New Albany Architectural Review Board Meeting Agenda
Monday, October 12, 2026, 7:00 p.m.

New Albany Architectural Review Board
September 14, 2026 Meeting Minutes – DRAFT

Architectural Review Board Staff Report
September 14, 2026 Meeting

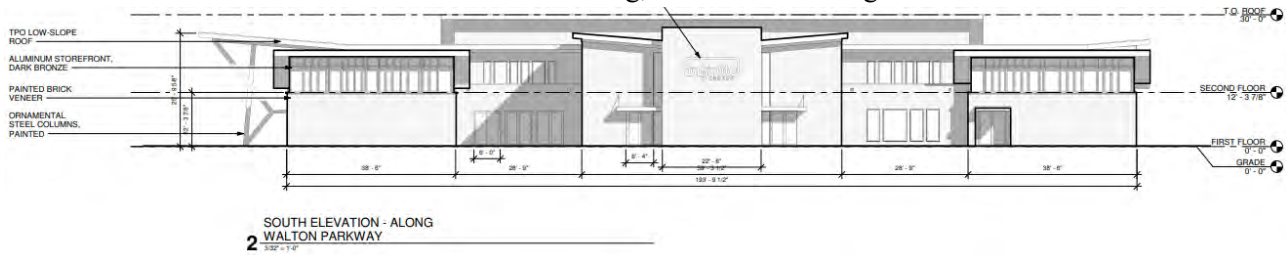
- Section 8(III.3) of the Design Guidelines & Requirements (DGRS) In keeping with traditional practice, the entrances to civic and institutional buildings shall be oriented toward primary streets and roads and shall be of a distinctive character that makes them easy to locate. Embraces shall be scaled and detailed to match the scale and detail of interior public space.

- o The proposed design provides entrances along Walton Parkway that are easy to locate on the building, as seen in the image below.

- o The main entrances are on the sides of the building where the awnings are and allow for more direct access from the parking lot.
 - Section 8(III.4) of the Design Guidelines & Requirements (DGRS) Civic and institutional designs shall follow the precedents of traditional American architectural designs, with particular care paid to the proportions of wall height to width; roof shape; and proportions of windows and doors, including vertically-proportioned window panes. The details and design characteristics of the traditional style selected for a new building shall be carefully studied and faithfully rendered in the new building's design.

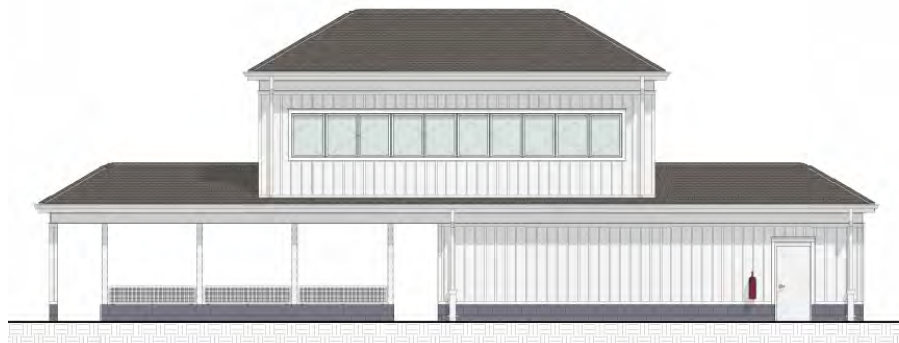
- The applicant proposes to construct a total of 12 buildings including home/visitor dugouts, home/visitor dugouts with a press box above, concession/restroom facility, standalone restrooms, hitting facility, and a water meter building.

- All buildings are proposed to be white fiber cement board and batten with a dark gray burnished CMU wainscot on the walls, and asphalt shingle roofs. The proposed buildings are consistent with the established character and architectural design of the existing athletic facilities on the school campus and are appropriately designed to complement the overall athletic field setting.

- The city architect has reviewed the proposed designs and commented that the project reflects an appropriate design approach, consisting of straightforward, simple forms that are partially utilitarian and partially stylized in character. The City Architect expressed general support for the design but recommended that the applicant provide a material sample showing the selected block with the proposed mortar, noting that the mortar selection can significantly influence the overall appearance of the finished material. Staff recommends a condition of approval that the applicant work with the city architect with the selected block and proposed mortar (condition #1).

A300

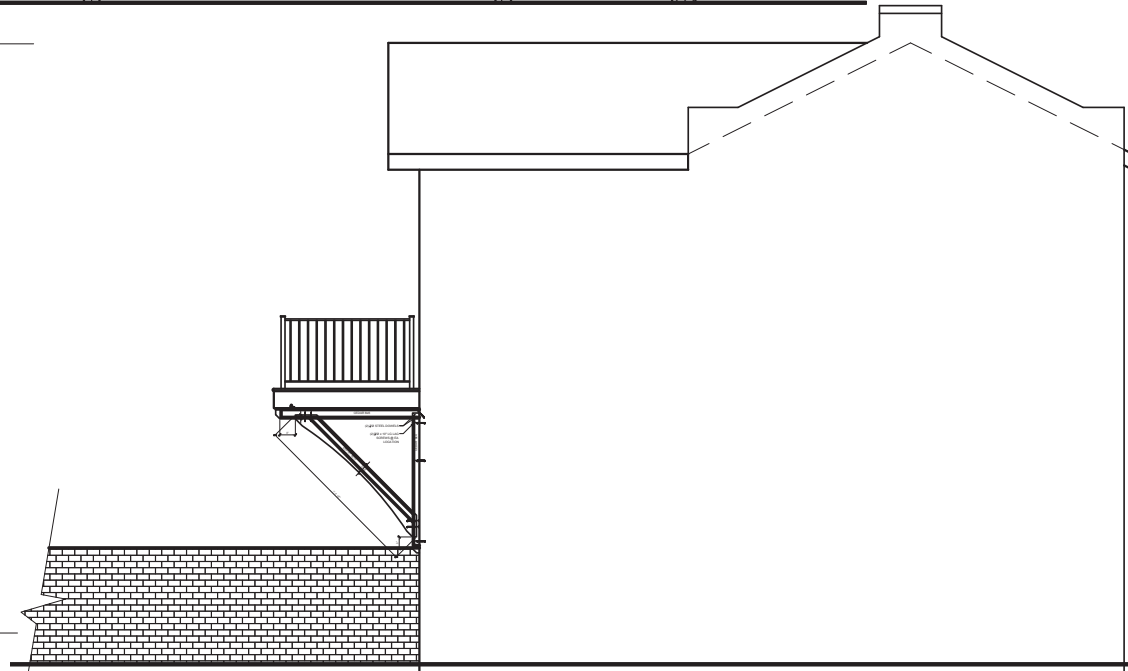
- The applicant proposes to replace windows on the rear first-floor elevation with three doors and extend the rear second-floor deck. The deck is proposed to be 21 feet and 1 inch. The proposed French doors will match the existing doors along the front facade of the building along South High Street.
 - The city architect has reviewed the proposal and recommended that a structural engineer review the French door additions due to the significant weight load in the proposed door location.

- The applicant is now proposing modifications to the original request, by extending the second-floor deck and adding three French doors on the first floor that match the appearance of the doors on the front facade. The primary building modifications are focused on the rear, which will not take away from the character of the existing structure.

Apollo Coffee Projecting Sign (1)

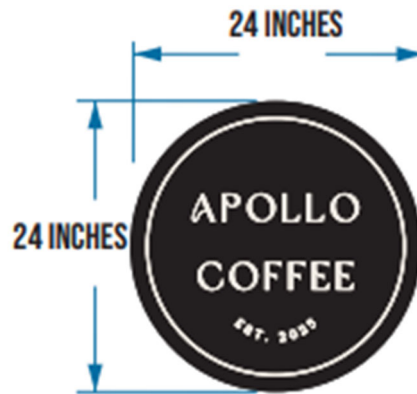
1. *The compliance of the application with the Design Guidelines and Requirements and Codified Ordinances.*
 - Per the city's sign code chapter 1169.14(a), each building or structure in the Historic Core sub-district shall be allowed three sign types. Hanging signs are a permitted sign type within the Historic Core sub-district.

- The sign does not block views in or out of the building and helps ensure that the tenant space is easily identifiable to pedestrians, improving mobility in the Village Center, which is an important goal of the Engage New Albany Strategic Plan for the Village Center.

The proposed sign appears appropriately located and sized to fit within the design of the existing storefront tenant space entrance on the North High Street elevation of the building. The proposed sign accomplishes the context and compatibility requirements of the city sign code and is similar to other signs within the Village Center. The sign does not block views in or out of the building and helps ensure that the tenant space is easily identifiable to pedestrians, improving mobility in the Village Center, which is an important goal of the Engage New Albany Strategic Plan for the Village Center.
